### MEMORANDUM

RE: Balakirsky Property, Lot 2  
11811 Chapel Estates Drive  
Clarksville, MD 21029  
*(BAT/LPD Comments)*

After review of the BAT/LPD plan here are my comments.

**BAT SITE PLAN**  
**11811 CHAPEL ESTATES DRIVE**  
 BALAKIRSKY PROPERTY, LOT 2  
 PLAT #23207  
 ZONING: RC-DEO  
 TAX MAP NO. 29 GRID NO. 14 PARCEL NO. 42  
 FIFTH ELECTION DISTRICT HOWARD COUNTY, MARYLAND  
 SCALE: AS SHOWN DATE: MARCH, 2018  
 SHEET 1 OF 3

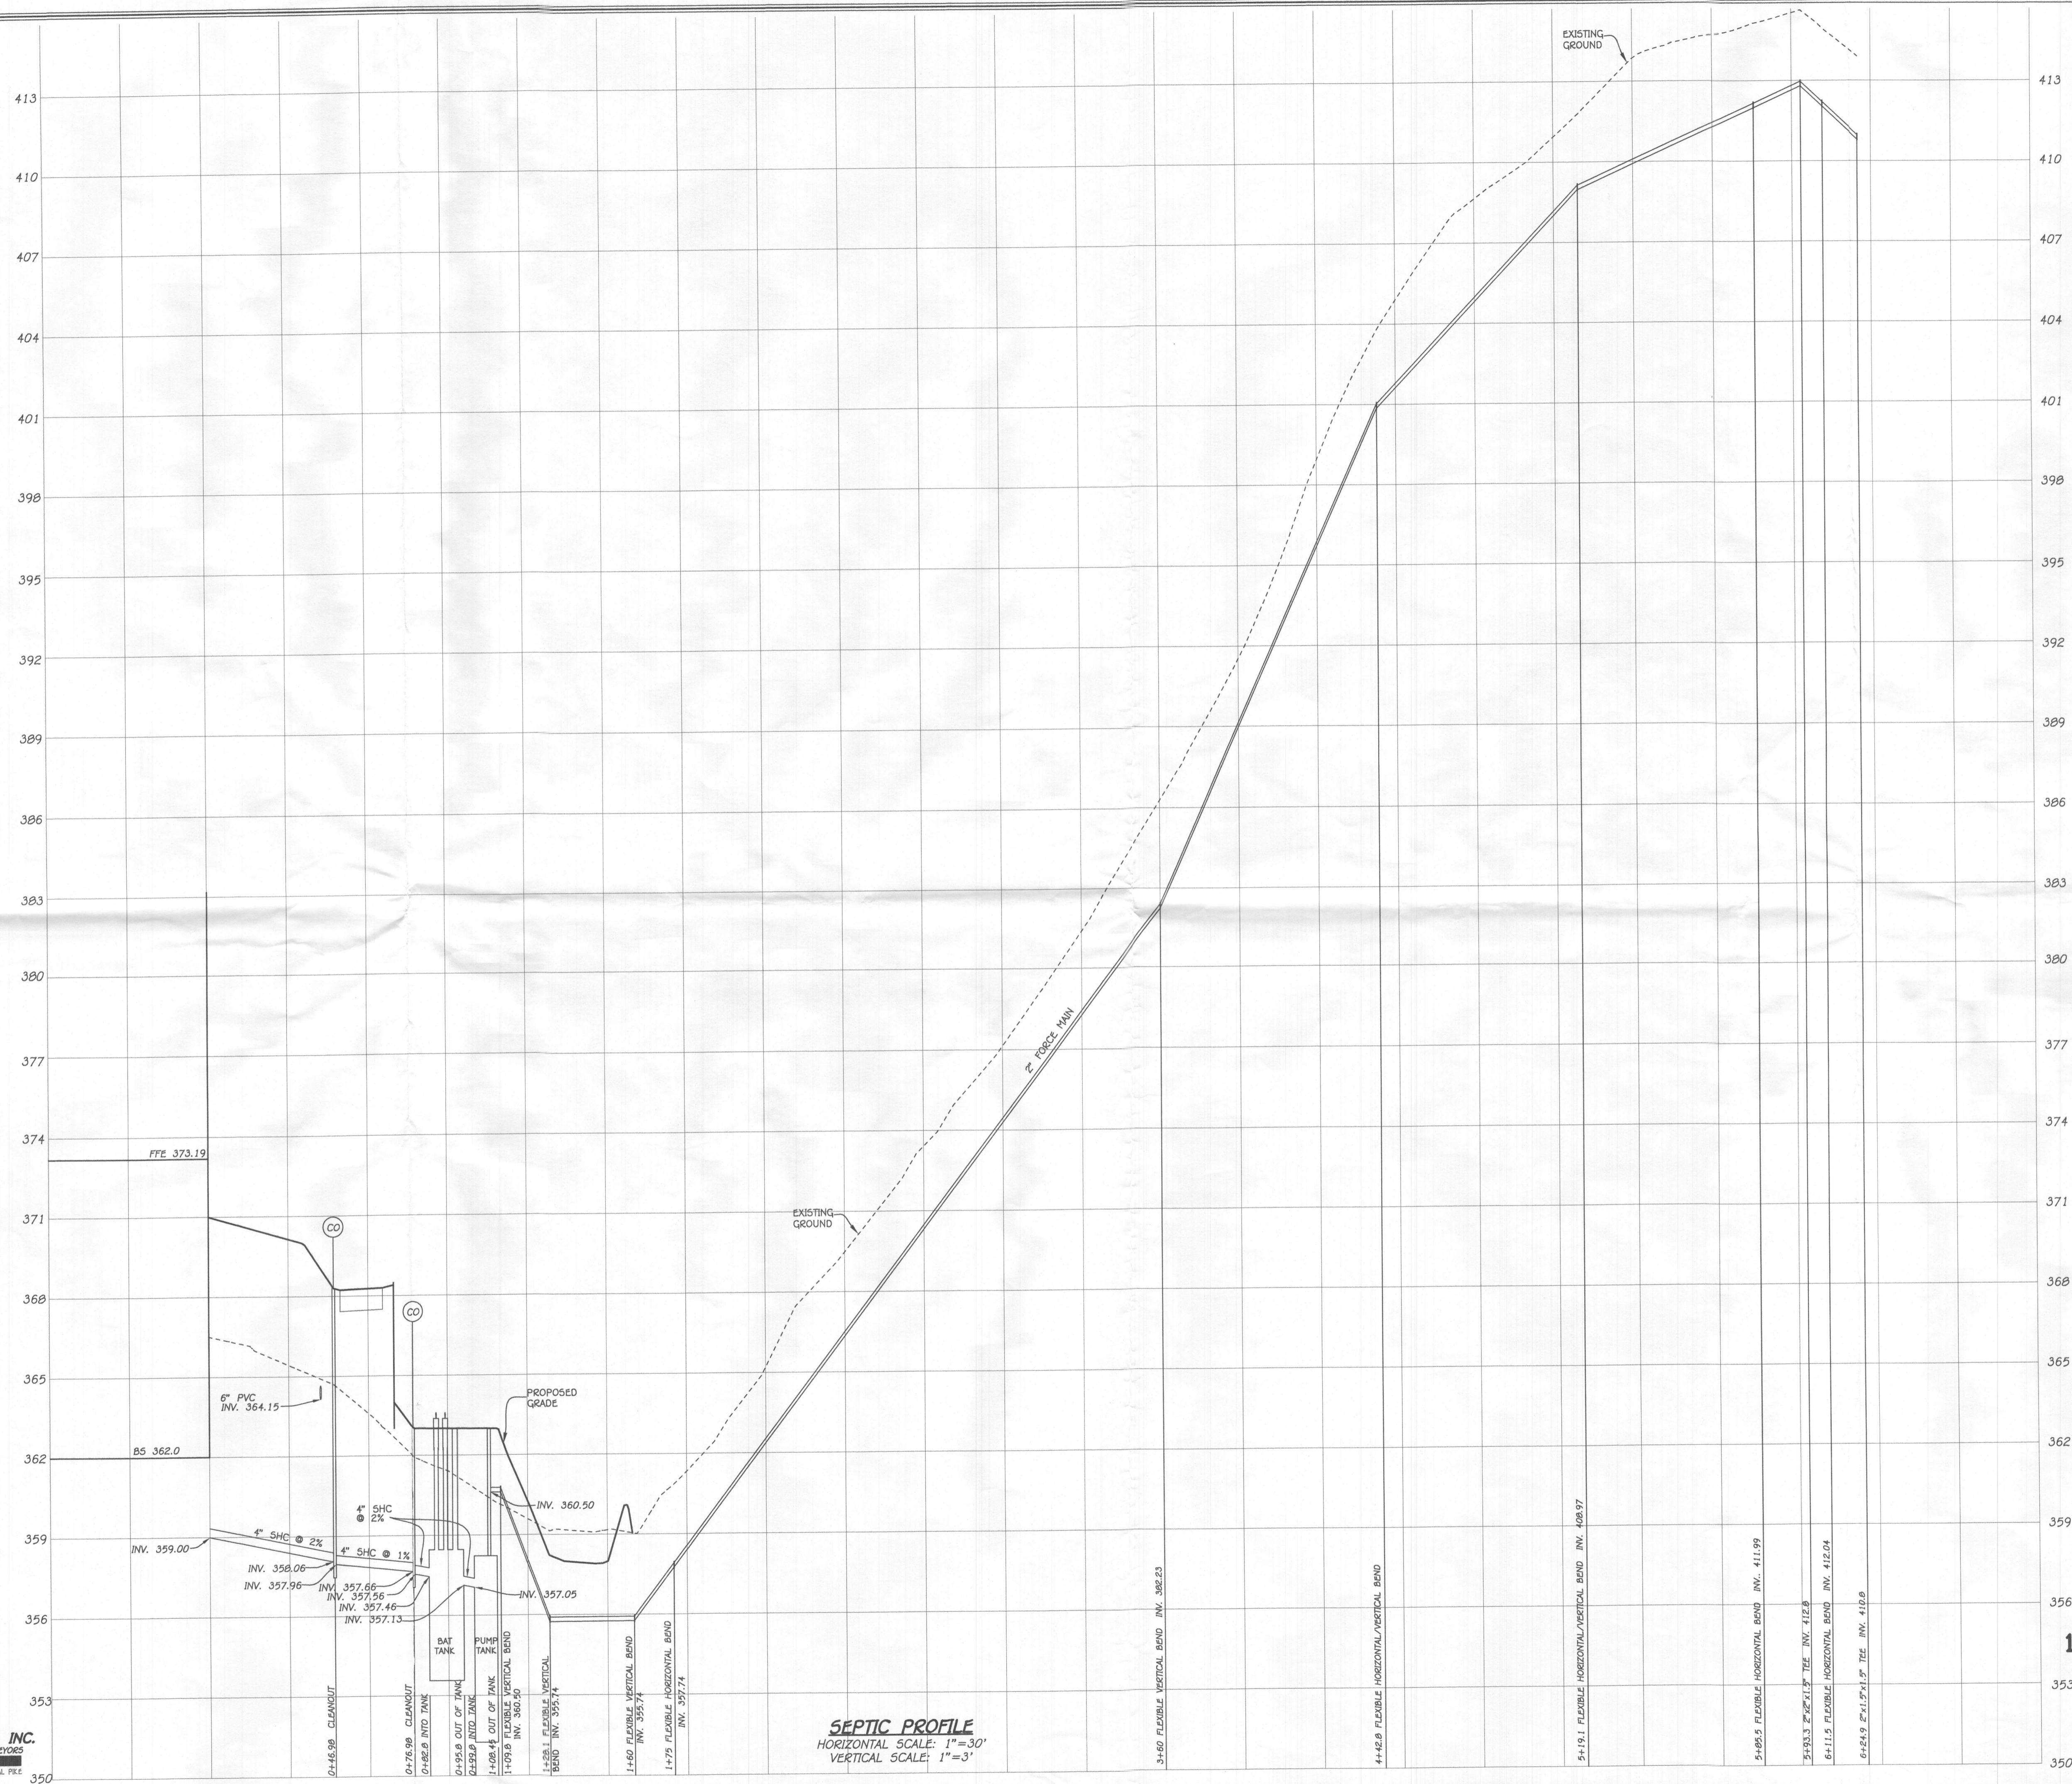
- ✓ There is a well box shown on the approved Perc Cert (4/5/13) that is not being shown on the BAT plan.
- ✓ The BAT Unit and pump tank must stay 25' from the retaining wall and 100' from any streams.
- ✗ *Stream SWM* Symbols used to represent different structures on the property should be clearly labeled in the legend. There are several symbols marked on the site plan that are not identified in the legend. Symbols that are not being used on the site plan should be removed from the legend.
- ✓ All septic tanks and pump tanks, including BAT units and heavy load bearing, shall have 3' of cover or less.
- ✗ The septic line from the house to the tank must be sleeved under the driveway and ~~retaining wall~~.
- The pumped sewer line diameter is inconsistently labeled between the site plan and calculations.

I understand we have allowed more than 3ft of cover over traffic bearing tanks prior to this point however we have been running into issues with this. Placing tanks deeper than 3ft below grade makes it increasing difficult for repair or maintenance work to be done. If there are no other options available we may consider installing a traffic bearing tank/s deeper than 3ft. As for the retaining wall, based on the site plan the wall looks to be about 4ft above grade and 5ft or less to the tanks. This is considered a steep slope greater than 25% which has a 25ft setback in COMOR Sec 26.04.02.04 (J). This is not listed on the *Well and Septic Program Setbacks* because it is not a common issue however it does come up time to time.

The point of the heavy load bearing is to have up to 5' of cover, so not sure what you mean.

Where is the 25' from retaining wall coming from? Never heard this before and not in the list of setbacks. This only a short wall. Even a house can be 20 feet from the tank, not that I have that much either.
